PRODUCT / PROCESS CHANGE NOTIFICATION

1.1 Company	 STMicroelectronics International N.V
1.2 PCN No.	EMBEDDED PROCESSING/26/16278
1.3 Title of PCN	STM32C53x and STM32C54x - Product Enhancement
1.4 Product Category	STM32C531x, STM32C532x and STM32C542x
1.5 Issue date	2026-07-15

STM32C53x and STM32C542x - Product Enhancement

for example, for **LQFP 32 7x7** package

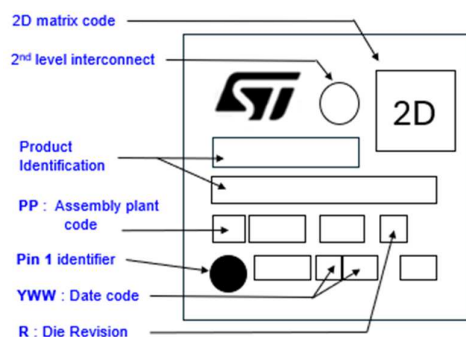
What are the changes?

Changes is visible on marking composition as shown in the table below:

Current condition	New condition
Front-End Diffusion site	ST Crolles 300 (France)	
Die revision Marking R	"Z"	"Y"
LQFP 32 7x7 (eg : STM32C531KCT6)
